Minnesota Department of Transportation

SUBJECT: Windermere
MnDOT Review # P17-001
SW quad of US169 and Marystown Road
Shakopee, Scott County
Control Section 7005

The Minnesota Department of Transportation (MnDOT) has reviewed the proposed Windermere development plat in compliance with Minnesota Statute 505.03, subdivision 2, Plats. Before any further development, please address the following issues:

9000E

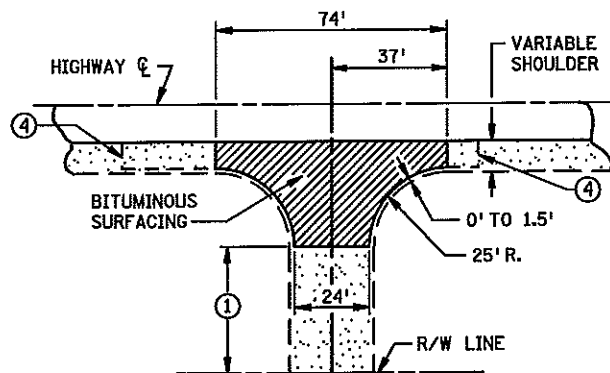
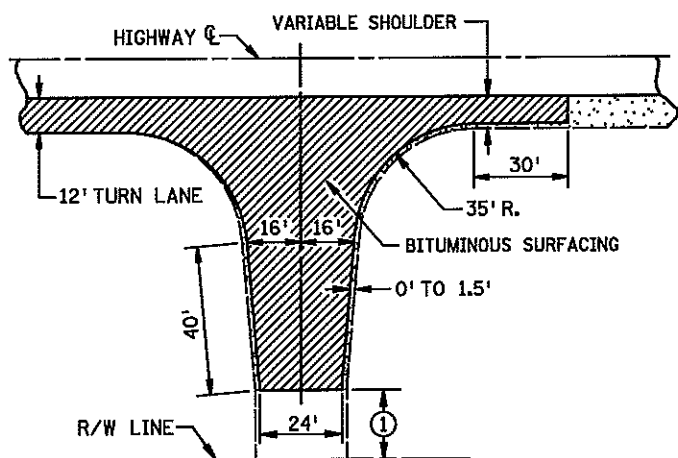
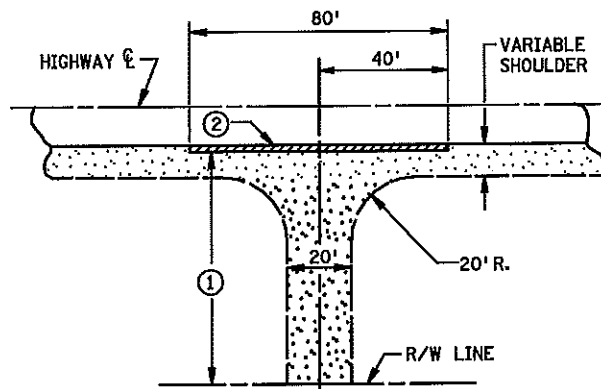
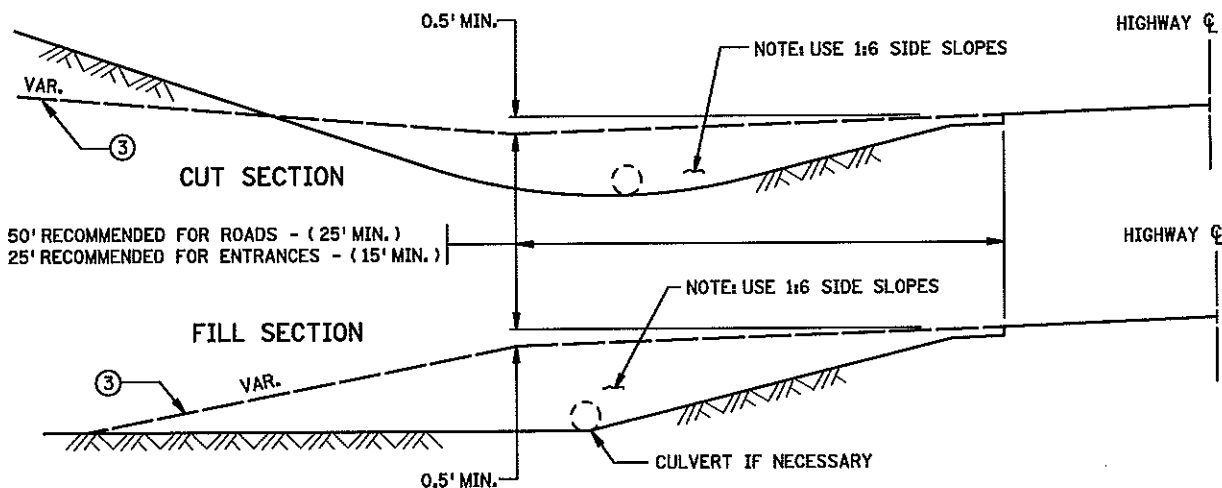
Ensure that the grades down to the Windermere Way culverts that are on MnDOT right of way are 1:6 or flatter. Reference the attached MnDOT Standard Plate 9000. The proposed retaining wall is very close to MnDOT right of way. No supporting elements of the retaining wall can be on MnDOT right of way.
